Representation from 42 Cherry Tree Road, East Finchley, London, N2 9QL

In respect of planning application HGY/2024/0871, submitted to Haringey on behalf of Fortis Green Tennis Club.

Fortis Green Tennis
Club

Site Section

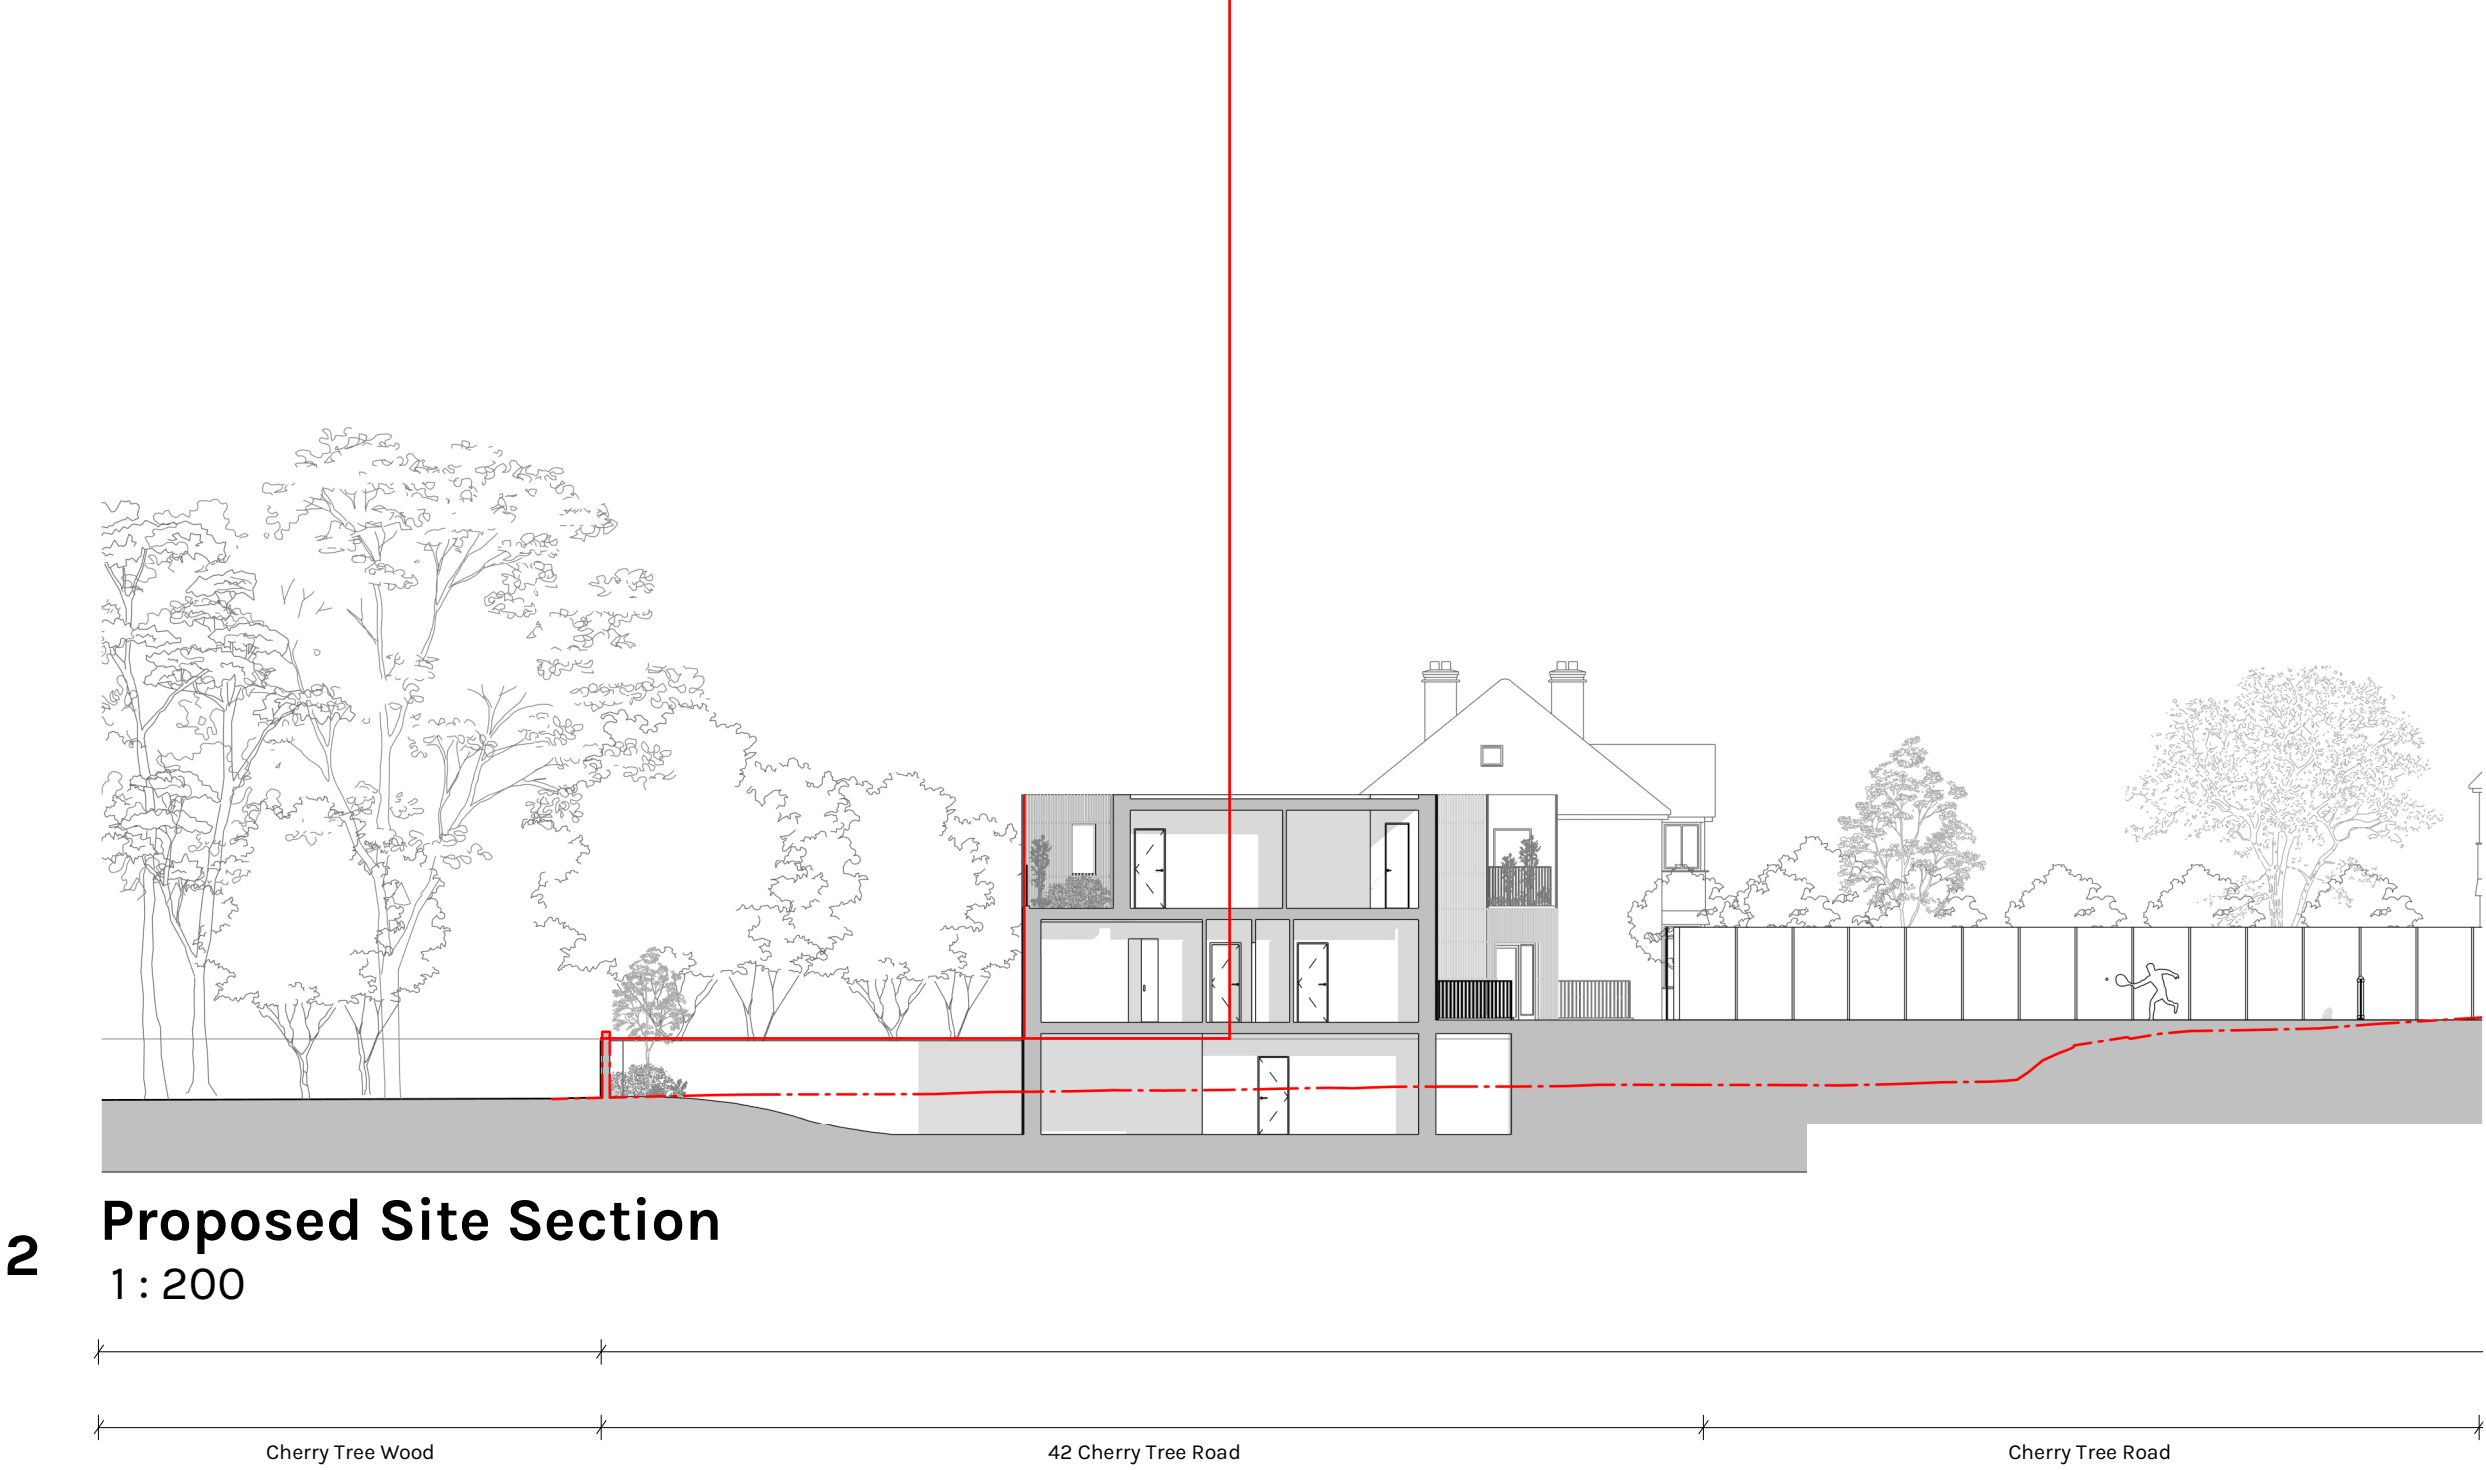
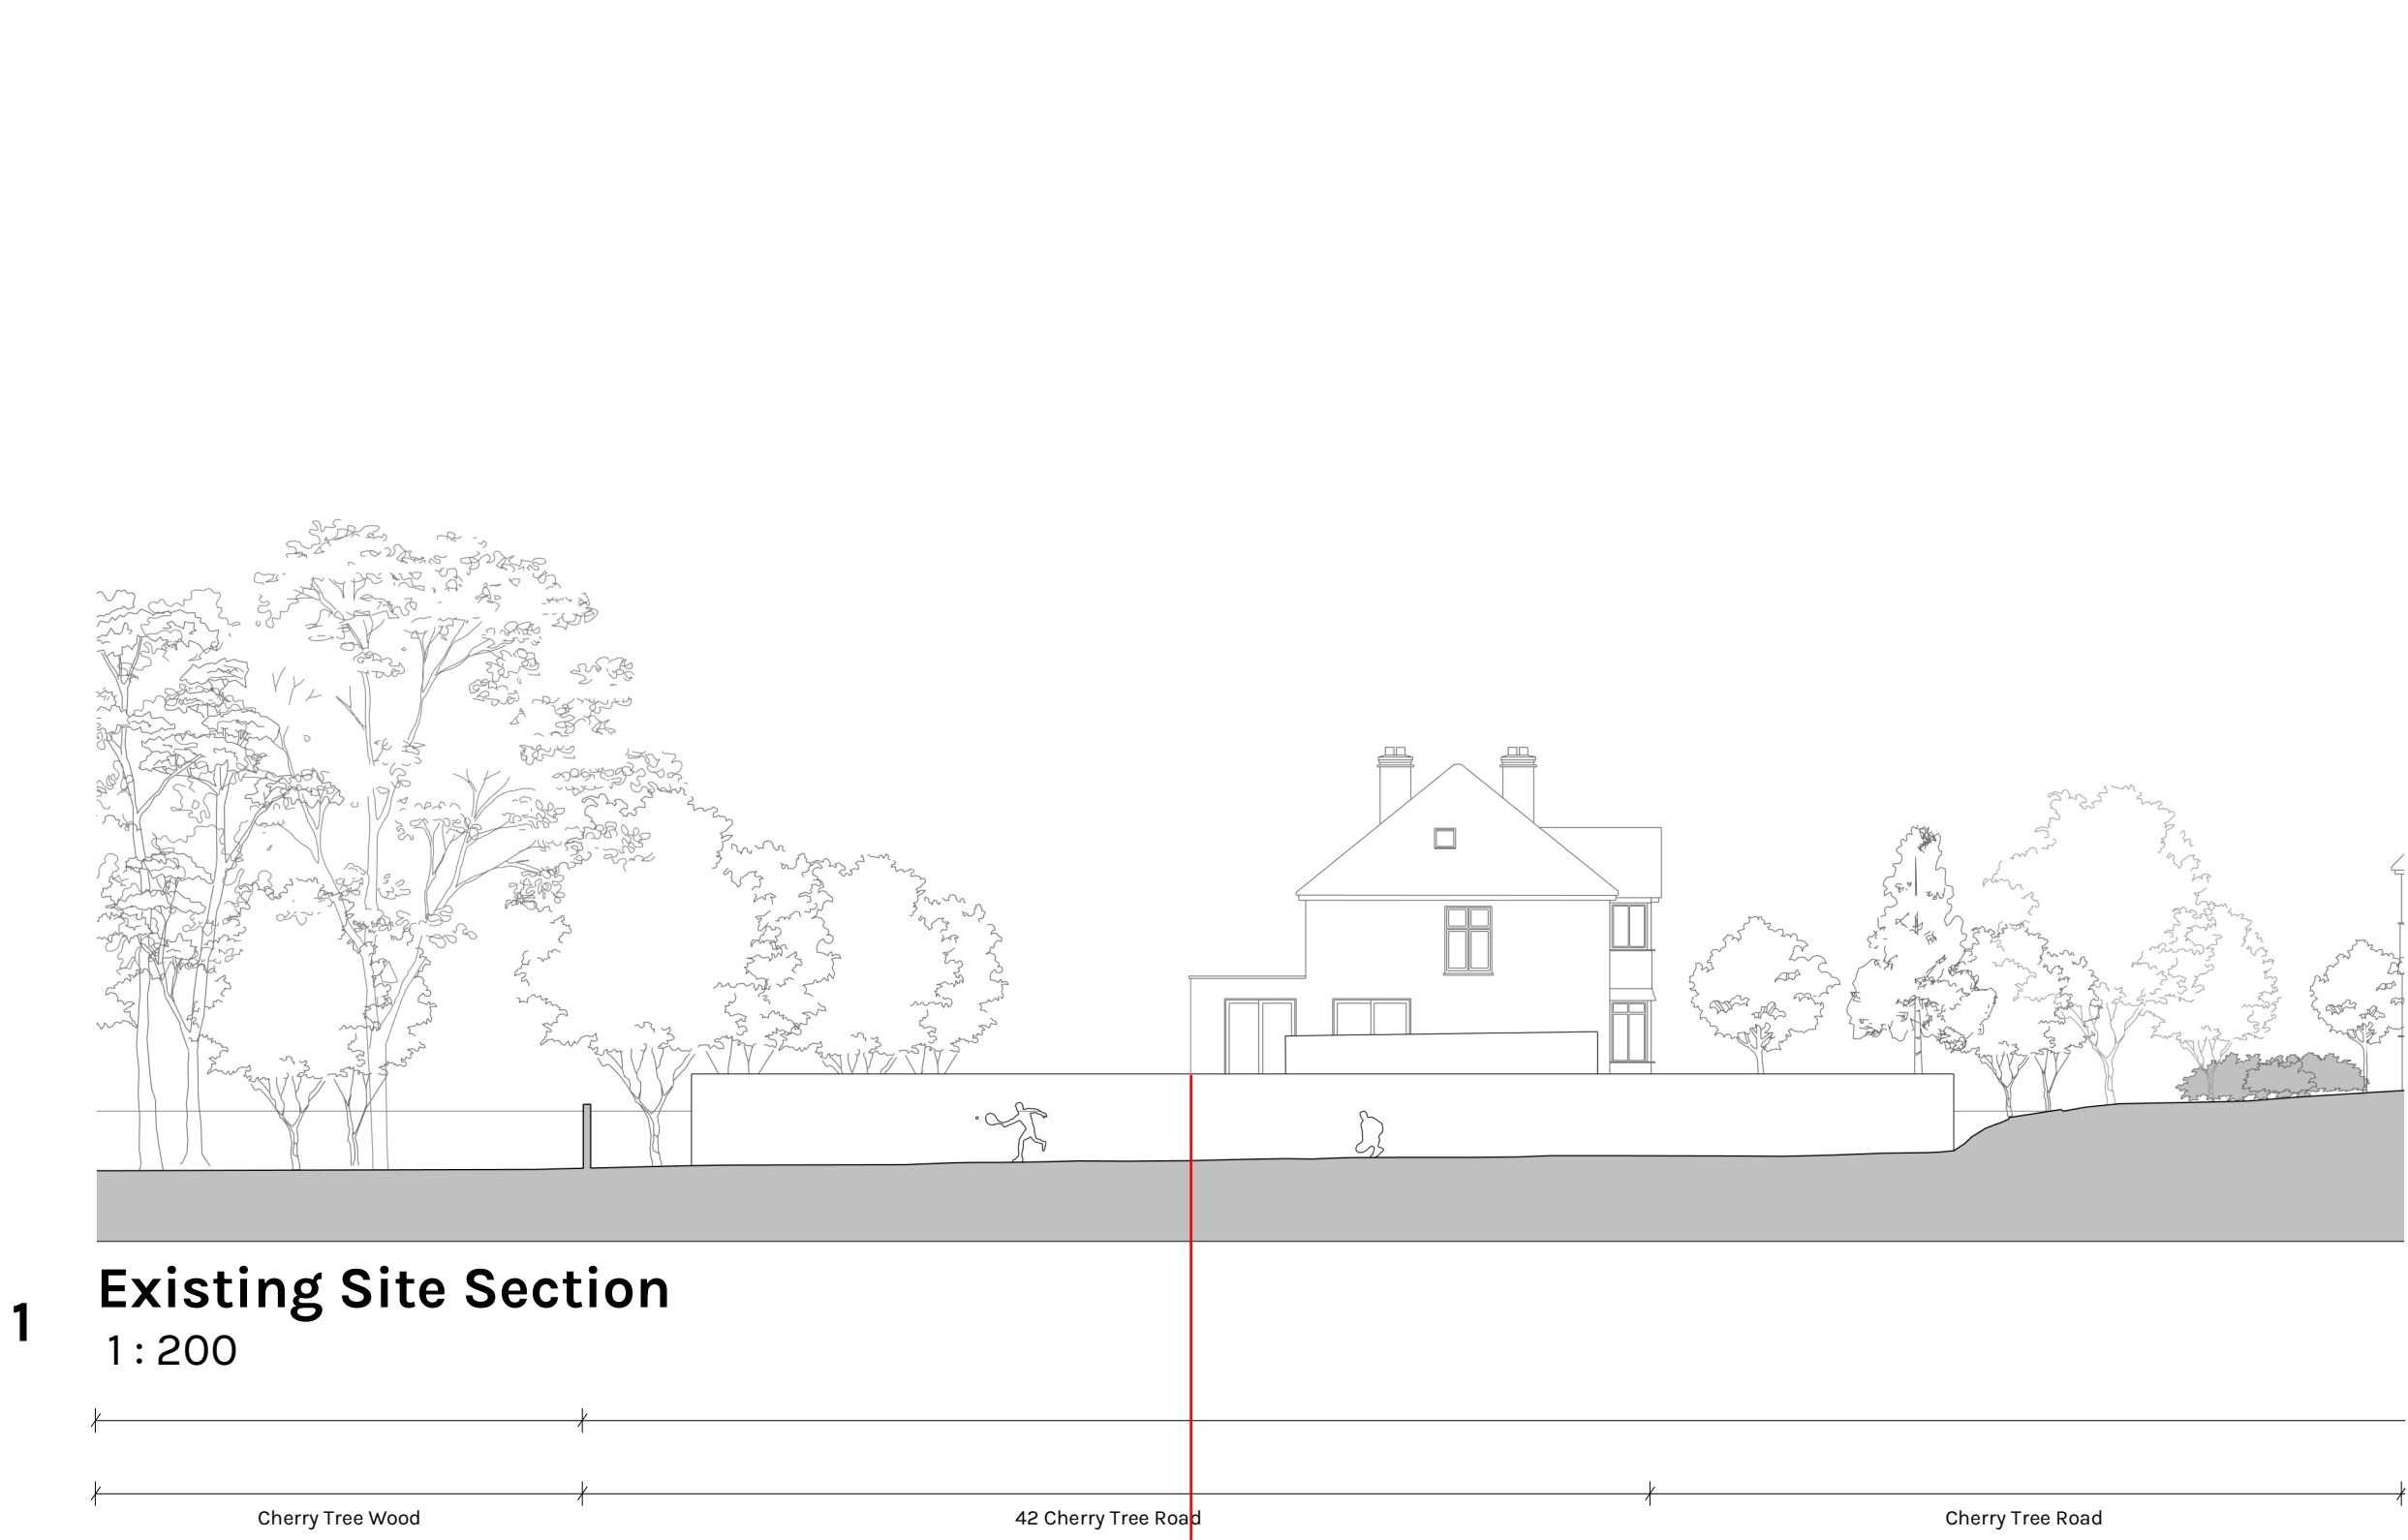
The proposals are in no way sensitive to the scale or built form of neighbouring properties. The design is completely incongruous with the street elevations in Cherry Tree Road. Existing building lines have not been followed through and the proposed housing, being set back and with it's close proximity to our property, is overbearing, causing detriment to amenity and light. (See prepared plan indicating level of overlooking)

The end terrace house includes a first floor balcony at a 45 degree angle which directly overlooks our garden affording no privacy. The balcony would also provide a direct line of vision into some of our habitable rooms. (The planning approval for our recent rear extension, 17/4834/HSE, included condition 5 relating to the proposed flat roof. This is to be used for maintenance only and not used at any time as a balcony.)
